ADDENDUM NO. 6

Job No. B78CO74A
Heeia Kea Small Boat Harbor Wastewater Treatment System Improvements
Kaneohe, Oahu, Hawaii
September 10, 2019

Sheet C008 shall be replaced by the attached revised Sheet C008.

SECTION "A-A"
ABSORPTION BED/INFILTRATOR CHAMBER DETAIL
NOT TO SCALE

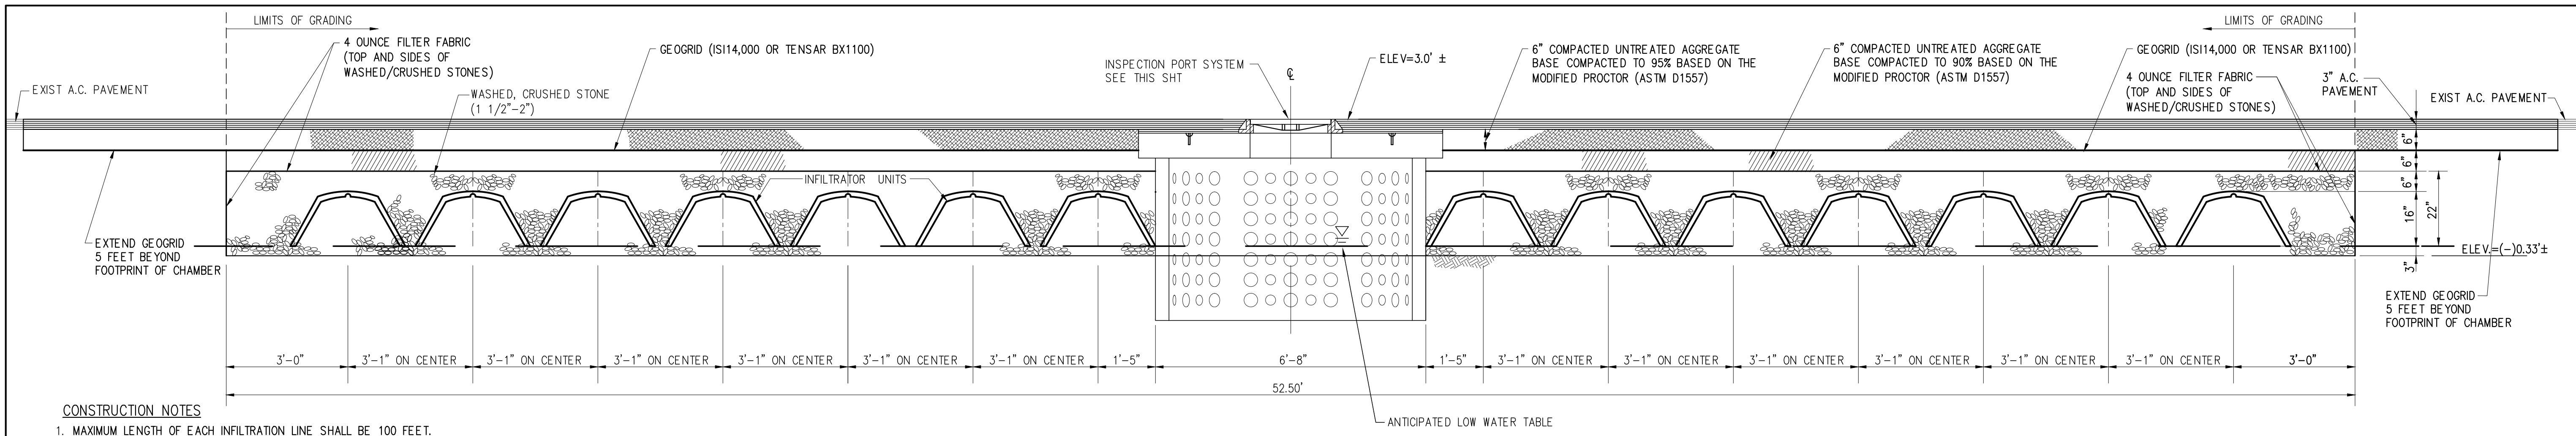
6. THE INFILTRATOR BEDS SHALL BE INFILTRATOR WATER TECHNOLOGIES HIGH CAPACITY INFILTRATOR CHAMBER H-20 OR ENGINEER APPROVED EQUAL. THE LAYOUT IS GENERIC. CONTRACTOR SHALL FOLLOW INSTALLATION DETAILS OF SPECIFIC INFILTRATION SYSTEM AS MODIFIED BY ITEM 7 OF THESE CONSTRUCTION NOTES TO ADDRESS COMPACTION AT BOTTOM OF ABSORPTION BED.

7. PLACE A LAYER OF GEOGRID (ISI 14,000 OR TENSAR BX1100) ON THE BOTTOM OF THE INFILTRATOR EXCAVATION. PRIOR TO PLACING THE GEOGRID, THE SUBGRADE SOIL SHALL BE MADE RELATIVELY SMOOTH. A 3-INCH LAYER OF CRUSHED ROCK SHALL THEN BE PLACED OVER THE GEOGRID. THE TOP OF THE CRUSHED ROCK SHALL BE TAMPED USING 4 PASSES WITH SMALL PLATE TAMPER.

ADDENDUM 1	MODIFY BOTTOM OF ABSORPTION BED/INFILTRATION CHAMBER	11 OF 29	9/6/2019	
REVISION NO.	SYM.	DESCRIPTION	SHT./OF	DATE
<p>THIS WORK WAS PREPARED BY ME OR UNDER MY SUPERVISION AND CONSTRUCTION OF THIS PROJECT WILL BE UNDER MY OBSERVATION.</p> <p>STATE OF HAWAII DEPARTMENT OF LAND AND NATURAL RESOURCES DIVISION OF BOATING AND OCEAN RECREATION</p> <p>HIEIA KEA SMALL BOAT HARBOR WASTEWATER TREATMENT SYSTEM IMPROVEMENTS</p> <p>MISCELLANEOUS DETAILS - 2</p> <p>BILLS ENGINEERING, INC.</p> <p>DESIGNED: DB SUBMITTED: BEI DRAWN: RE/SI DATE: CHECKED: DB SCALE: AS SHOWN APPROVED: DATE: AS SHOWN</p> <p>CHIEF ENGINEER DATE DRAWING NO. C008</p>				
<p>DAVID B. BILLS LICENSED PROFESSIONAL ENGINEER No. 4516-C HAWAII, U.S.A.</p>
